First Article Inspection Record (AS9102)

1. Part Number 191Z2544-904	2. Part Name INSPAR RIB-44	3. Part Serial Number K0003	4. FAI Report Number F41010479
5. Part Revision Level 02W	6. Drawing Number See the attached #1	7. Drawing Revision Level See the attached #1	8. Additional Changes N/A

IP-NO: IP_191Z2544-904_00

Engineering Definition Release View Capture

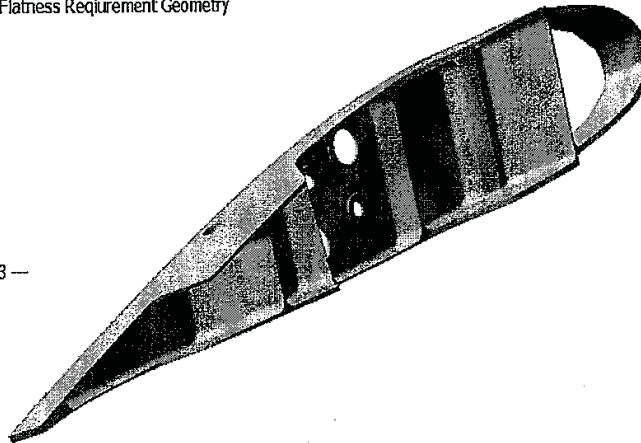
IP는 MBD No.를 사용하는 것으로 통일

Part No. 역시 MBD No.를 기입하는 것으로 통일
RH 부품에 LH MBD를 적용하는 경우 별도 구분하지 않아도 됨
